NG-09-0764
10 CFR 54

Duane Arnold Energy Center
Docket 50-331
License No. DPR-49

Response to Request for Additional Information Regarding the Review of the License
Renewal Application for Duane Arnold Energy Center

Enclosure 1 to NG-09-0764
Duane Arnold Energy Center License Renewal Application
Response to Request for Additional Information

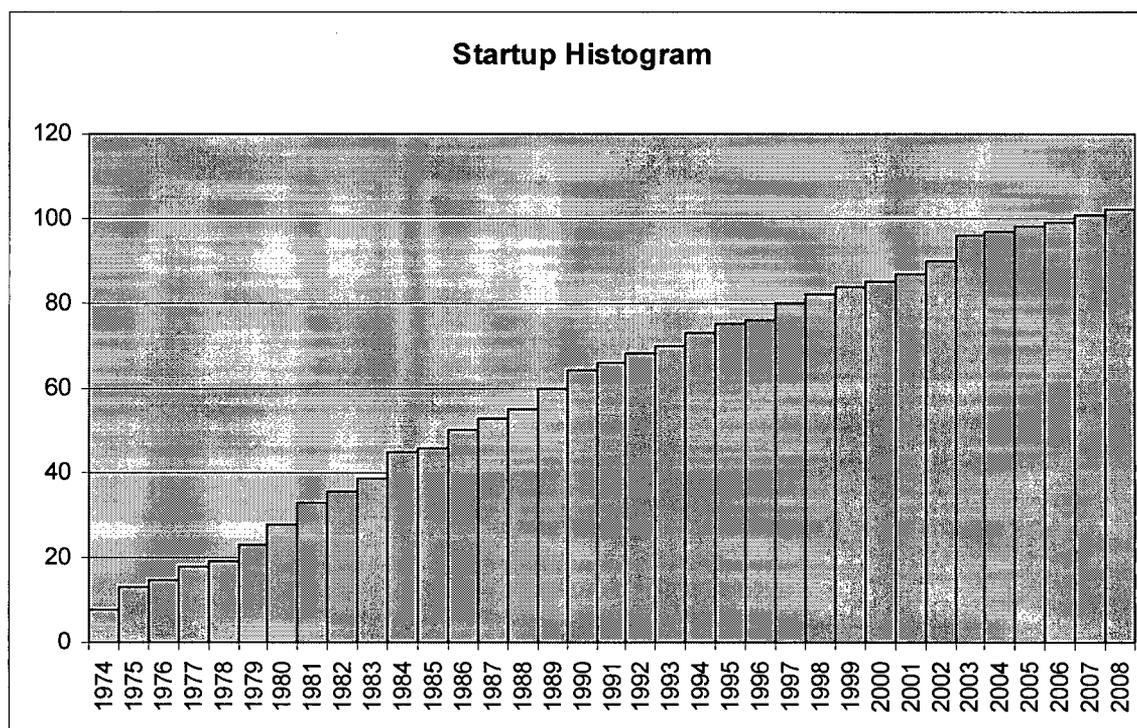
A histogram for cumulative plant startups is provided below. Since the number of shutdowns is equal to the number of startups on a cyclic basis, but not a yearly basis, the numbers may vary by 1 (i.e., when the plant is operating, the cumulative number of startups is one greater than the cumulative number of shutdowns).
